January 20, 2026

**RE: REVIEW OF INLAND WETLANDS APPLICATION**  
**Proposed 100-Unit Multi-Family Development**  
27 Beecher Road, Woodbridge, CT

*REMA Job No.: 26-2859-WDB6*

FIGURE B:  
BEDROCK GEOLOGY  
27 Beecher Road, Woodbridge, CT

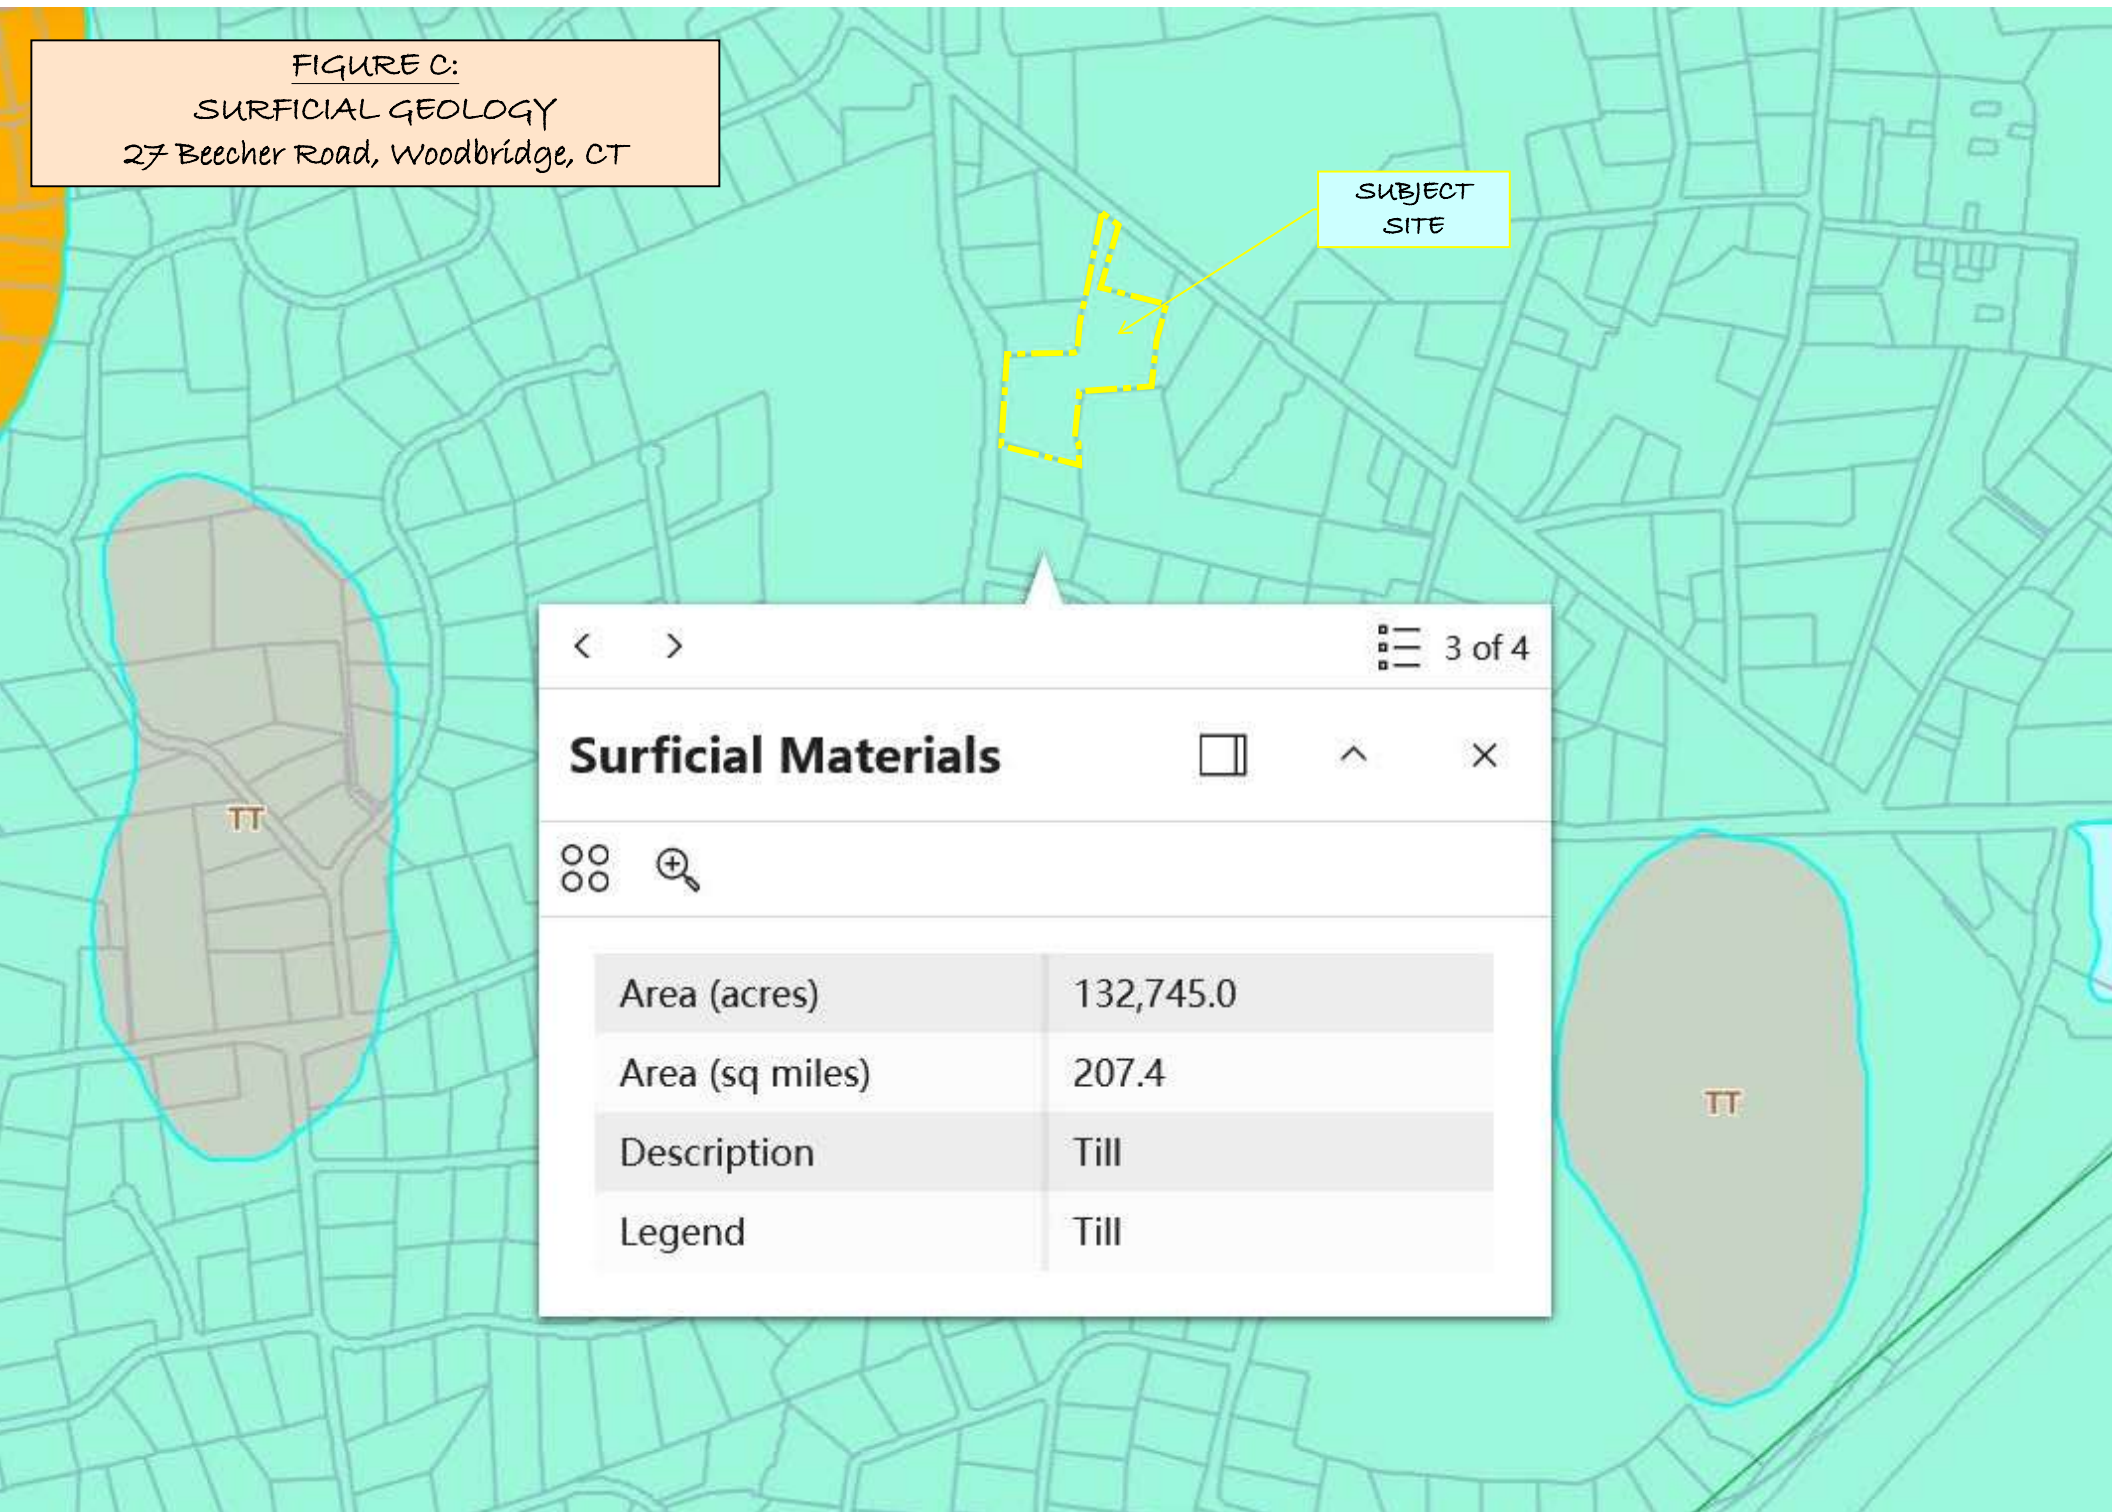
The soils discussion in the Environmental Assessment begins with a substantive geologic error. The glacial melt-out till soils underlying the site are not underlain by gneiss, as stated, but by the Wepawaug Schist formation, consisting of medium- to fine-grained schist or phyllite (see Figure B, attached). Accurate identification of underlying geologic materials is critical to evaluating infiltration capacity, groundwater movement, and the potential for perched or rising water tables.
